# Service Bulletin

## Service Bulletin No. 205

### Turbocharger V-Band Torque Verification

Figure 1 - Turbocharger V-Band Coupling, Typical

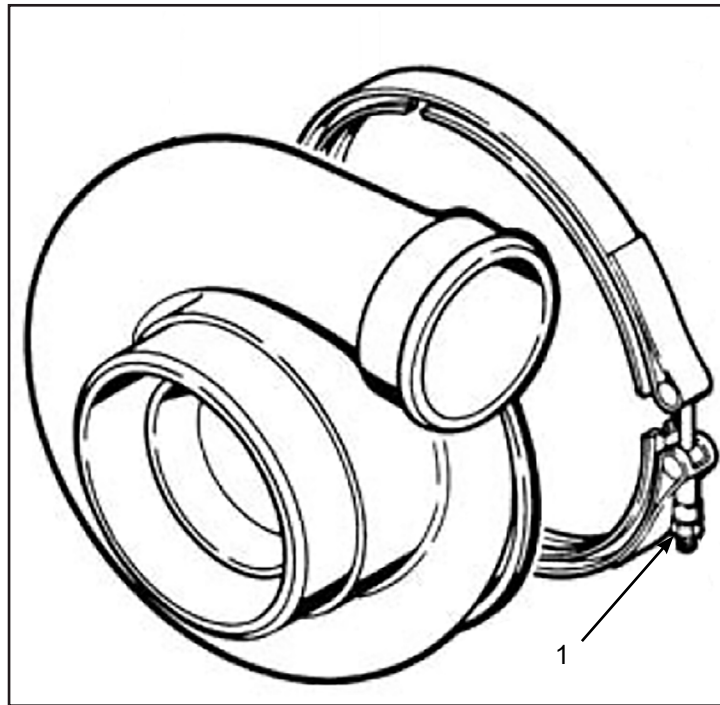
- (1) Hartzell Engine Tech has discovered that affected turbocharger v-band lock-nut (1) torque specifications referenced in 400600-0000 Rev. New thru Rev. D are incorrect.
  - (a) This condition could compromise the integrity of the v-band retention system.

- (1) V-band torque check
  - (a) Gain access to the turbocharger in accordance with applicable aircraft/engine maintenance manual and service instructions.
    - 1) Inspect the v-band coupling for looseness.
      - a) If the v-band coupling is found loose on the housing:
        - 1: Contact HET customer support prior to taking action.
      - b) If the v-band coupling is not found loose on the housing:
        - 1: Using a calibrated in-lb torque wrench, inspect the v-band coupling lock-nut (1) torque against the turbocharger models referenced in Table 2, this document.
        - 2: If the locknut (1) torque is not within specification, adjust torque in accordance with Table 2.
        - 3: If the locknut (1) torque is within limits, continue to 3.C, Return to service.

Turbocharger Model	V-Band Locknut Torque Value
T18A	110-130 in-lbs (12.43-14.69 Nm)
TA61	110-130 in-lbs (12.43-14.69 Nm)
TA8102	130-150 in-lbs (14.69-16.95 Nm)
TE06	40-60 in-lbs (4.52-6.78 Nm)
TH08	40-60 in-lbs (4.52-6.78 Nm)
TH08A	40-60 in-lbs (4.52-6.78 Nm)
